NEW RECREATIONAL R/V SITE
EXIT 1 R.V. RESORT, LLC.
CLYDE MEITZIER ROAD
NICHOLSON MS MISSISSIPPI 39466

SHEET TITLE:
SITE POWER PLAN

DRAWING NUMBER:
E100

1 SITE ELECTRICAL PLAN
SCALE: 1" = 60'-0"

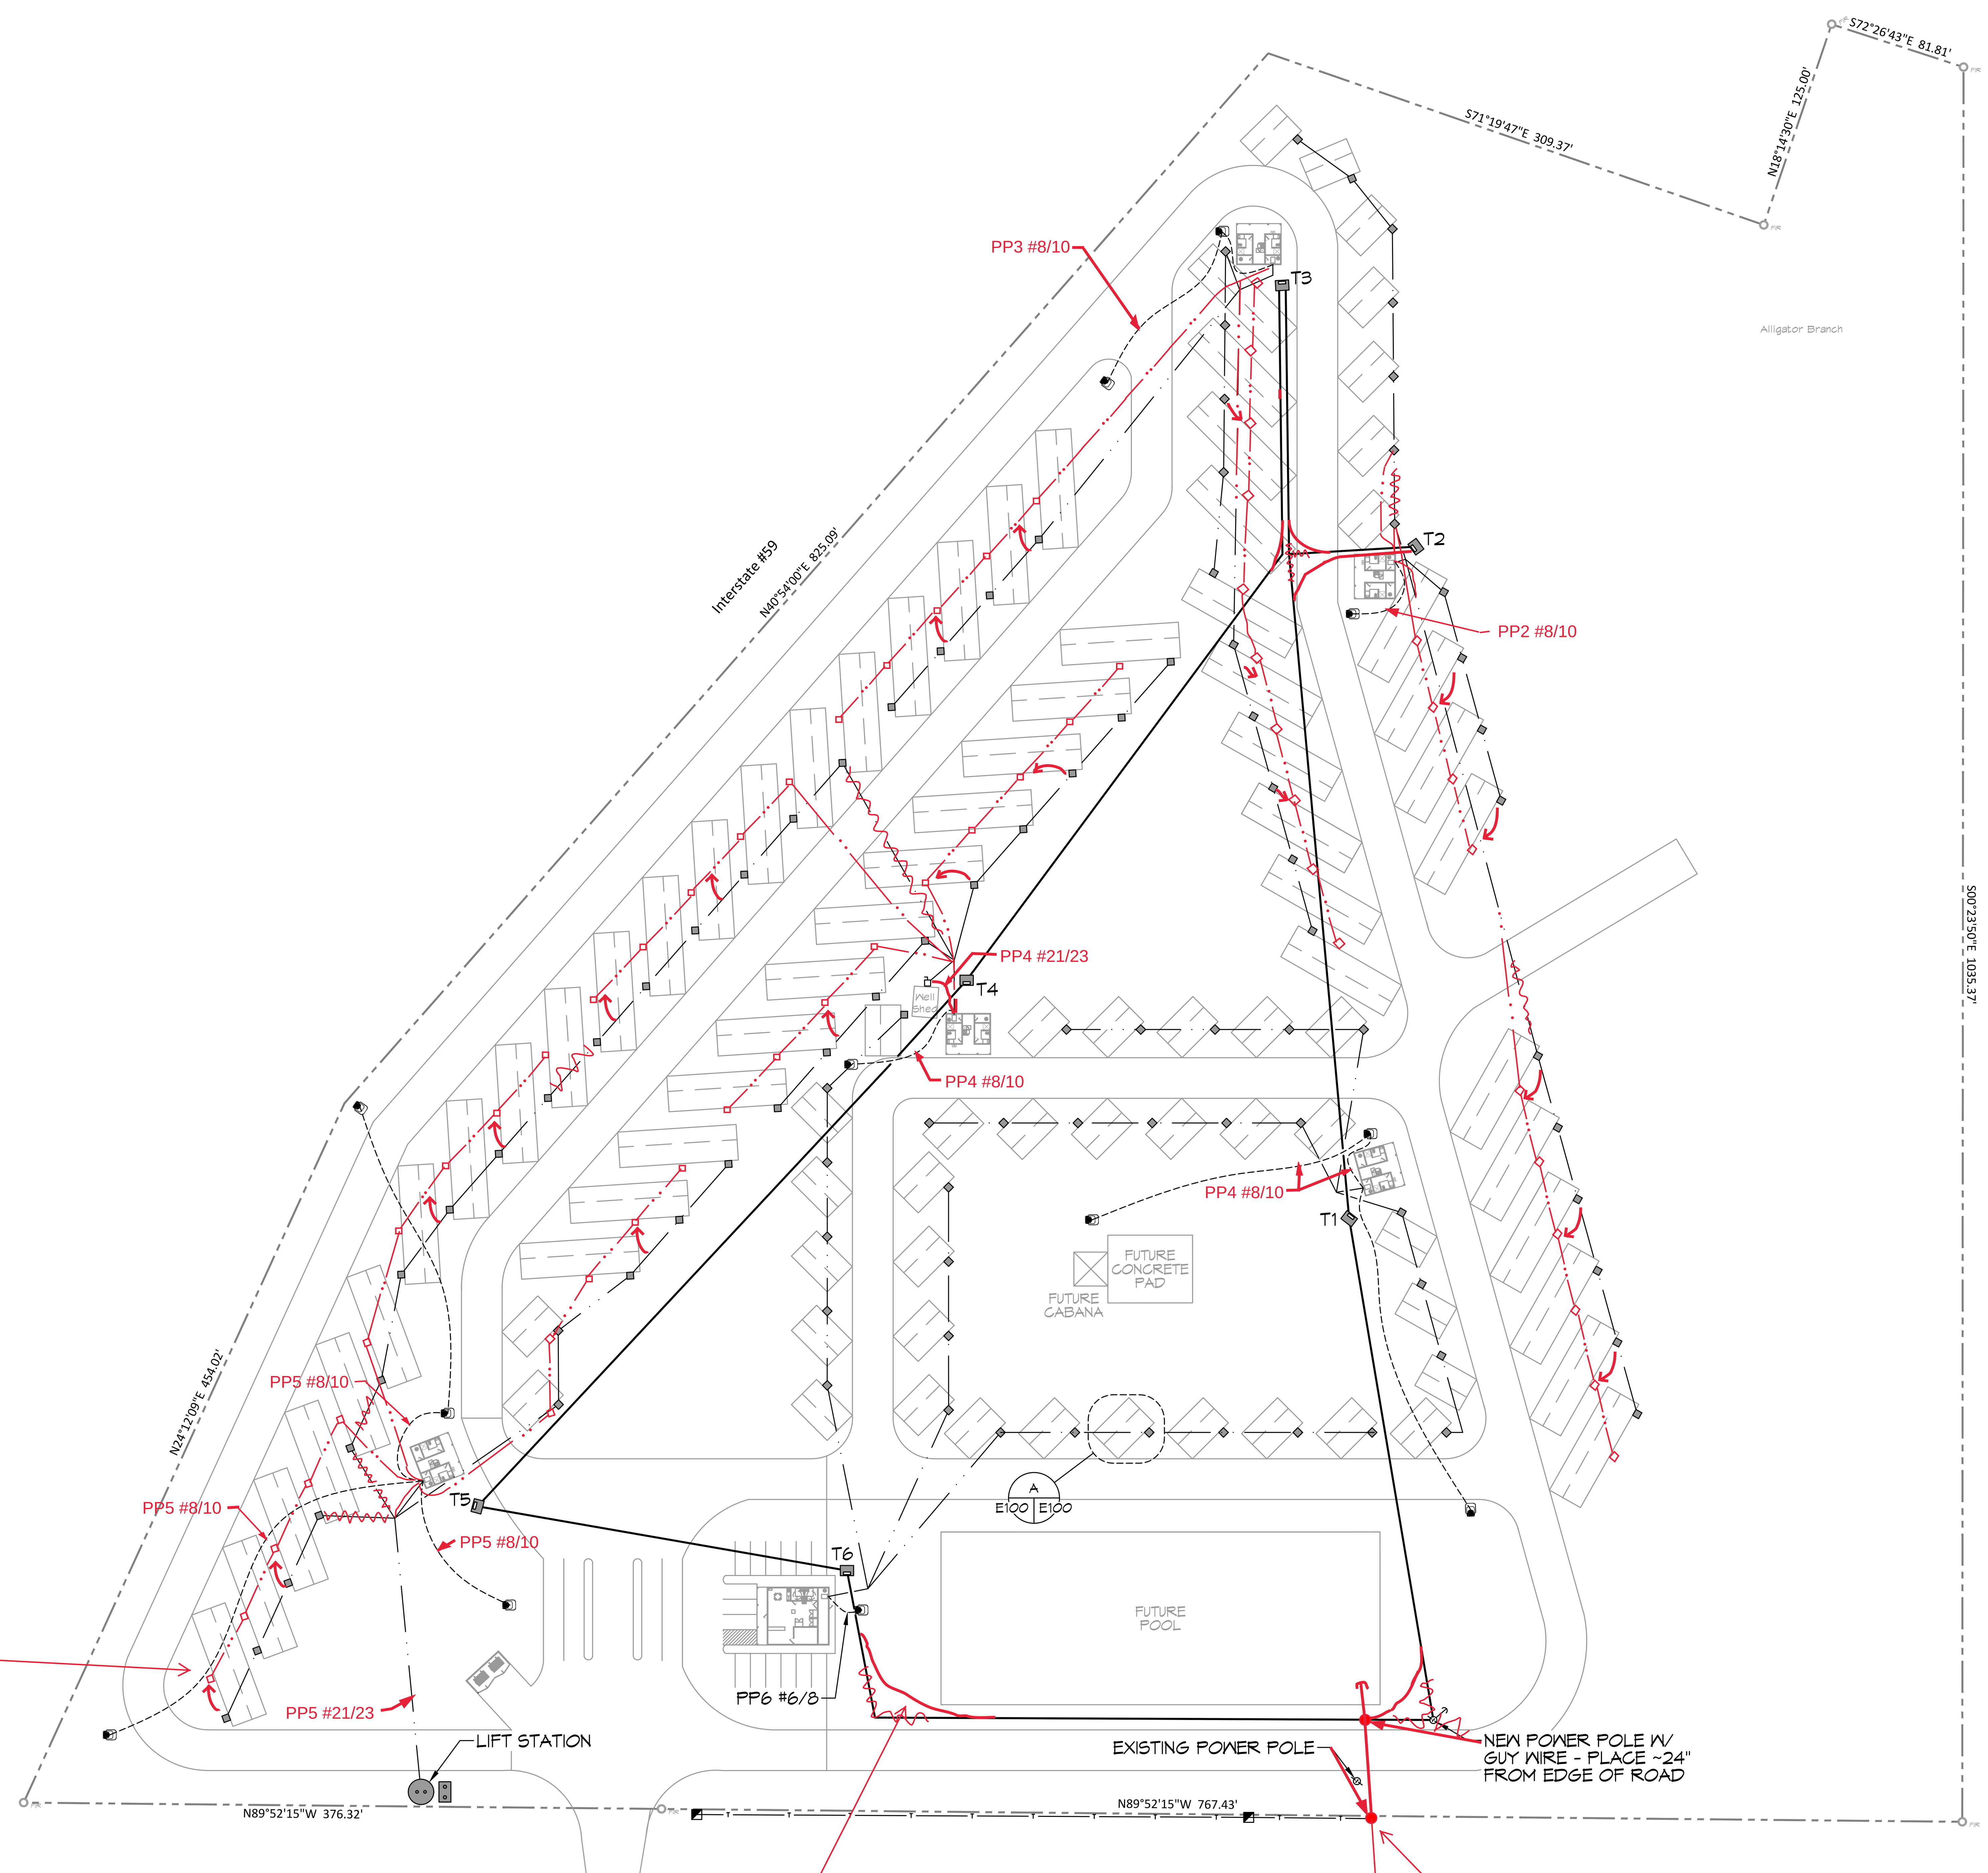
The RV Pedestals should be located on the driver's side of the RV about midway of camper site

Tim,
Please draw a very large radius here.
The PVC pipe can be bent to conform to the curve.

Tim,
The existing overhead power line runs through the woods to this point. The existing line needs to be guyed so it will not fall down.

Tim,
This existing pole is on the property line
